The Calcutta Gazette

APPENDIX.

NOTICES TO MARINERS.

The following Notices are republished for general information.

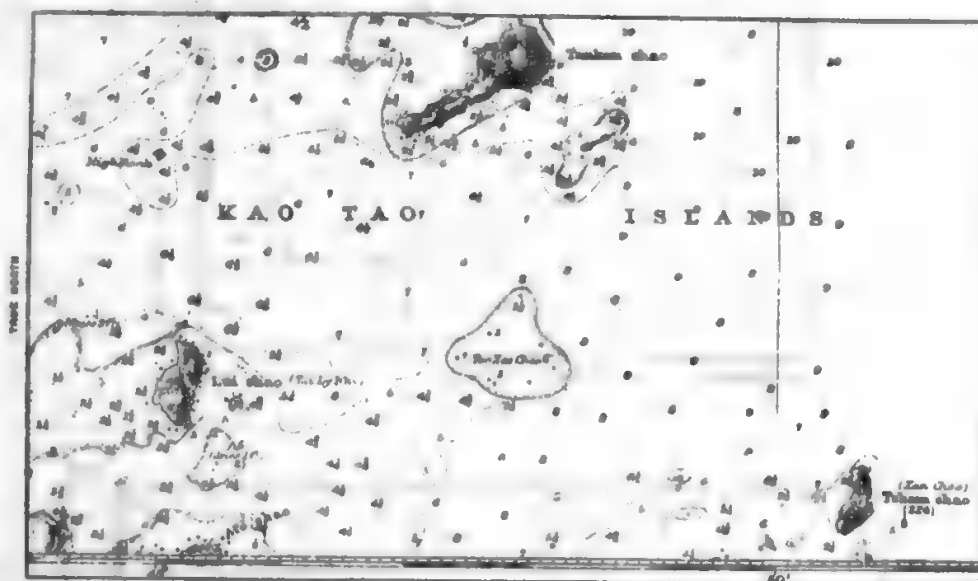
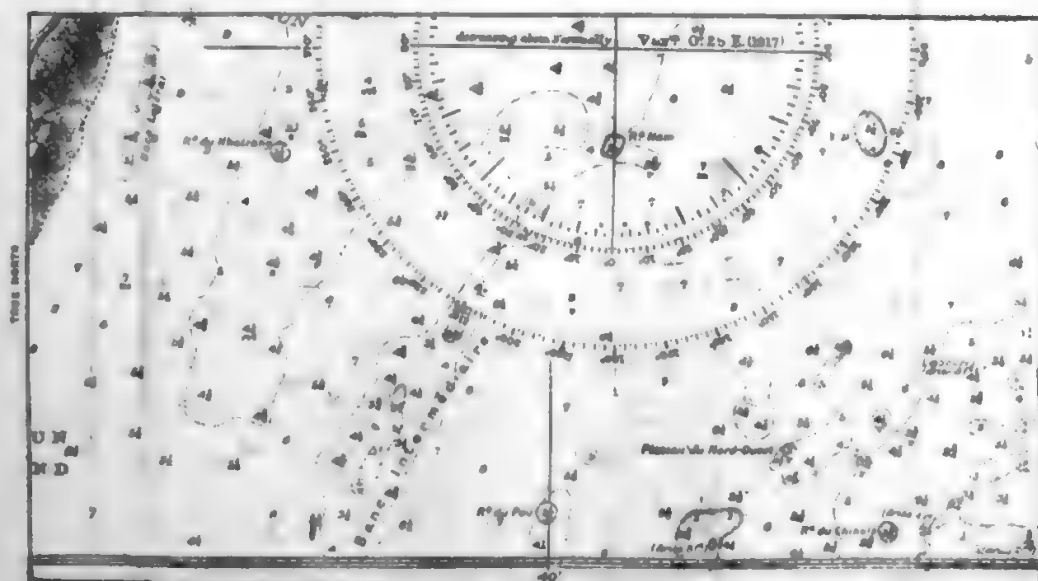
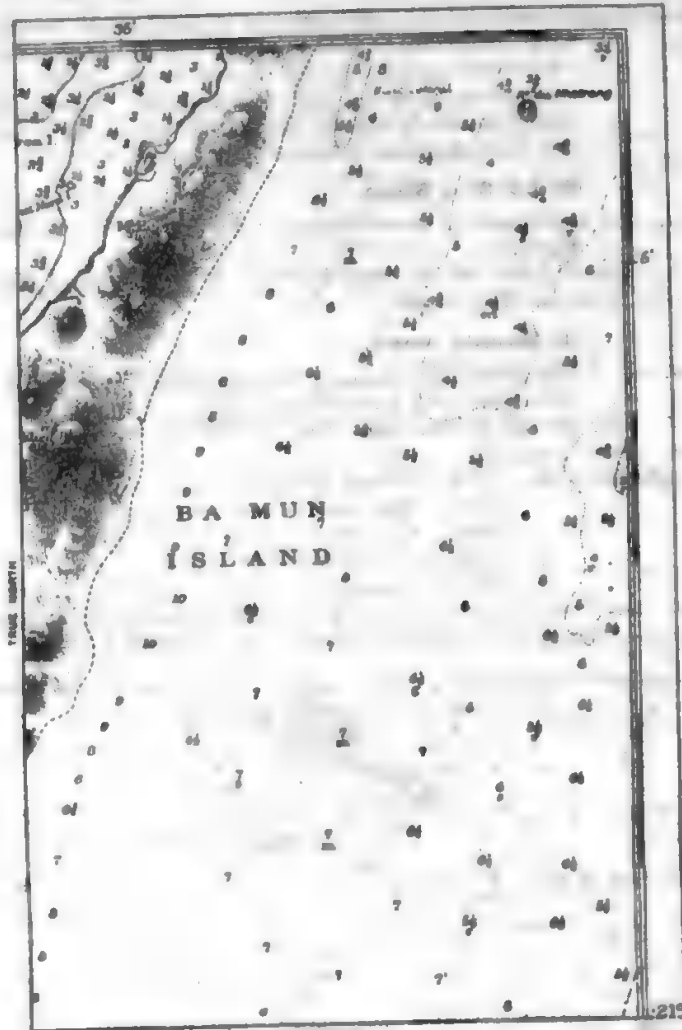
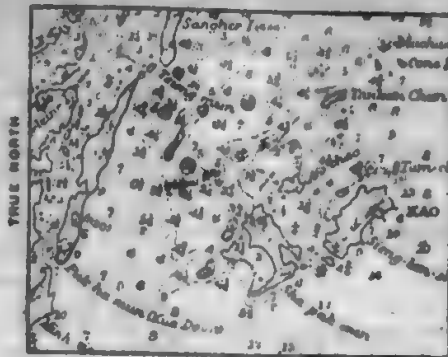
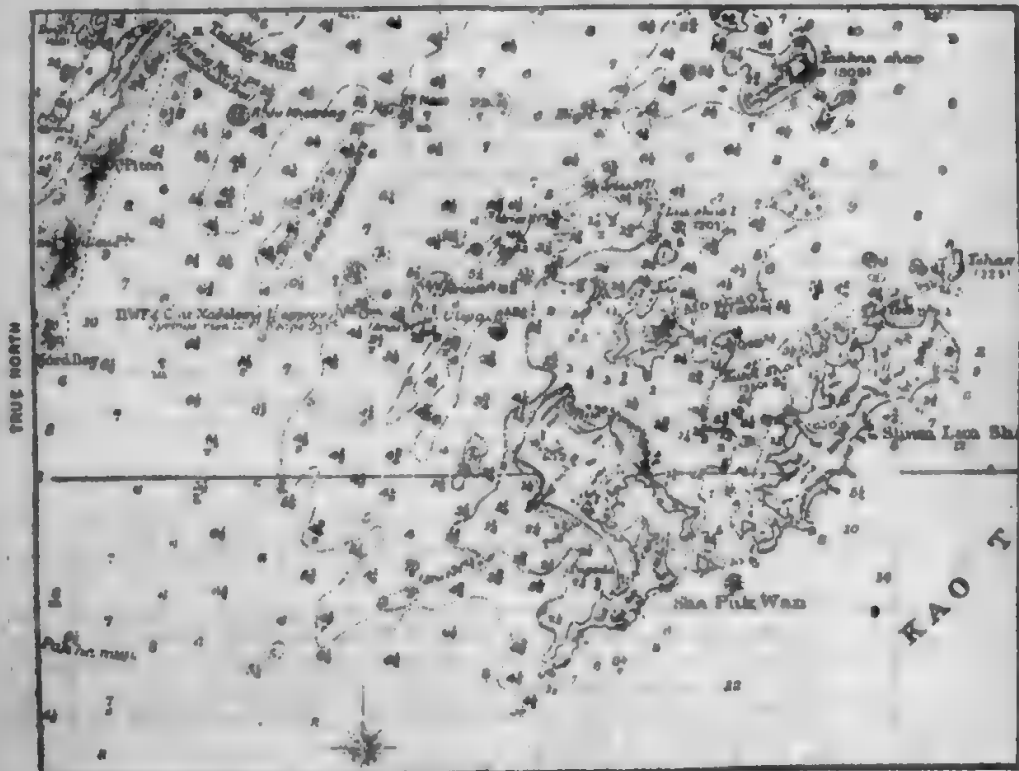
Details.—The accompanying reproductions of portions of charts Nos. 776, 1965, 1169, 2062 and 2661a, show the necessary amendments to the charts with regard to shoals and depths in the vicinity of, and to the westward of the Kao Tao islands. The depth on Hugon rock at the southern end of Sanglier island is one fathom (1^m8), and not 1½ fathoms as hitherto shown on the charts.
